**DEFENSE NUCLEAR FACILITIES
SAFETY BOARD**

Staff Issue Report

SUBJECT: Seismic Qualification of Fire Suppression System at the Plutonium Facility, Los Alamos National Laboratory

Figure 1: Example of fire suppression piping underneath unsecured equipment.

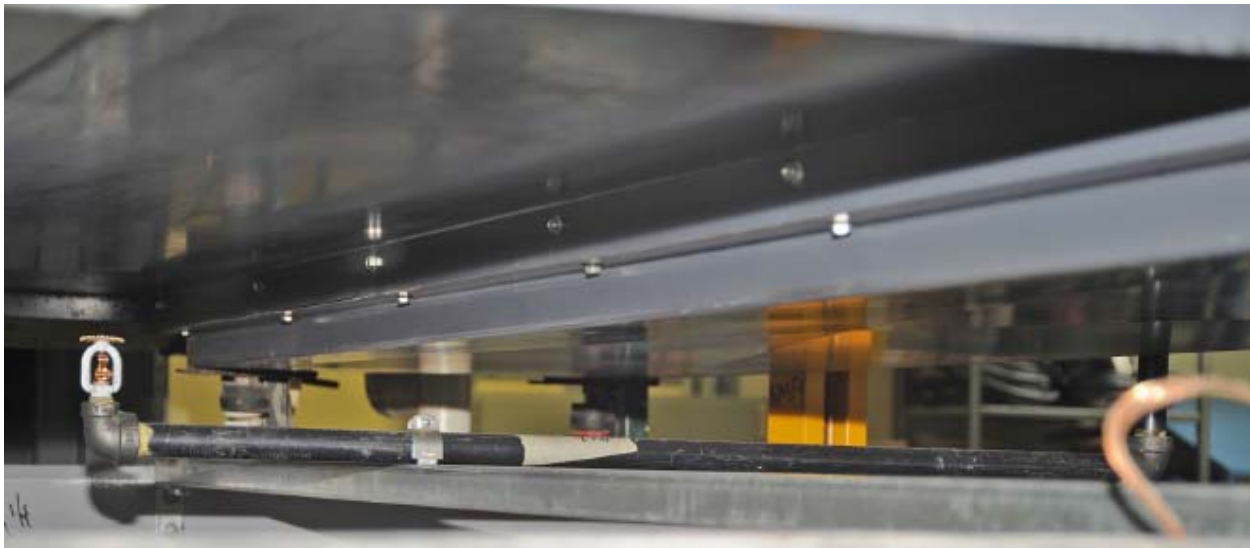
During the November 30, 2015, walkdowns, the staff review team found that a number of the seismic interaction concerns identified by LANS in 2010 still existed [5]. Most notably, large air handlers were installed above fire suppression piping without adequate seismic anchorage and bracing (Figure 1). Damage to the fire suppression piping from falling equipment, such as these air handlers, would lead to a loss of water and hydraulic pressure in the facility, impairing its function after a seismic event. The site's structural engineers could not provide the staff review team with a technical justification for why this condition does not pose a seismic interaction concern. They acknowledged that not all seismic interaction effects have been dispositioned for the FSS.
